File No.: A0746/19NY

Address: 31 Roslin Avenue

31 Roslin Avenue – Staff Report

Attachment 1: Site Plan

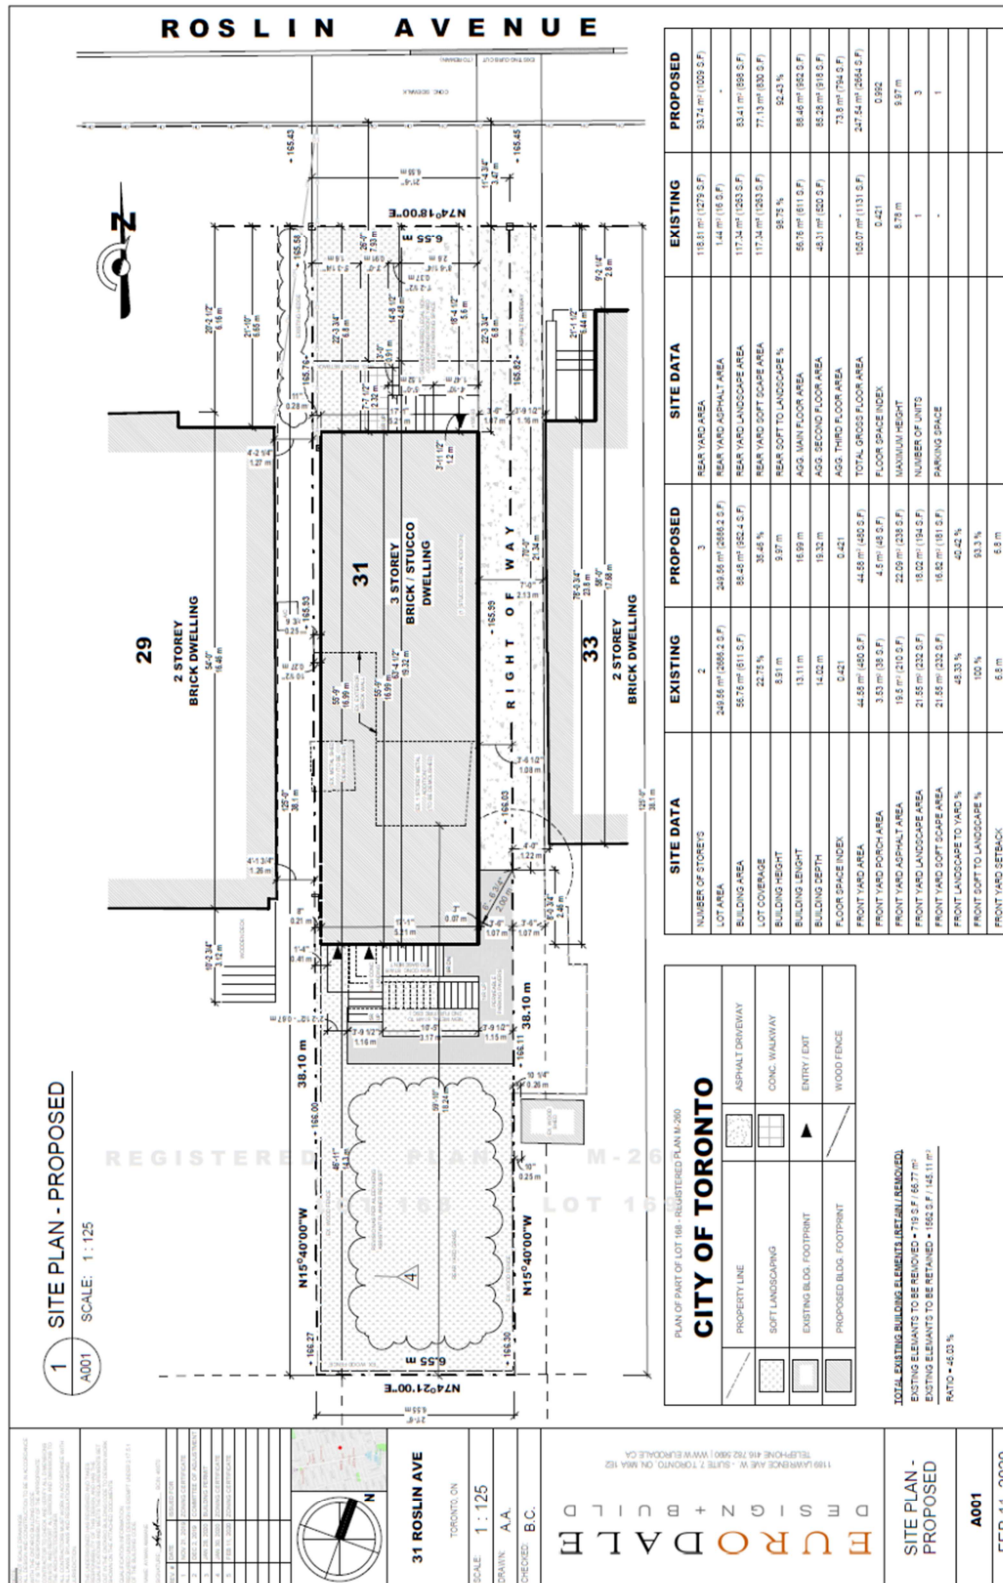
1. The proposal be developed in accordance with the site plan, east and west side elevation drawings attached to this report; and,
2. The applicant is to provide permanent opaque privacy screening along the east and west sides of the proposed rear second storey balcony with a minimum height of 1.5 m from the balcony floor.

City Planning staff are of the opinion that the variances being requested maintain the general intent of the zoning by-law. Should the Committee of Adjustment approve this application, City Planning staff recommend the proposal be developed in accordance with the site plan, east and west side elevation drawings attached, and that permanent

opaque privacy screening be provided along the east and west sides of the proposed rear second storey balcony with a minimum height of 1.5 m from the balcony floor.
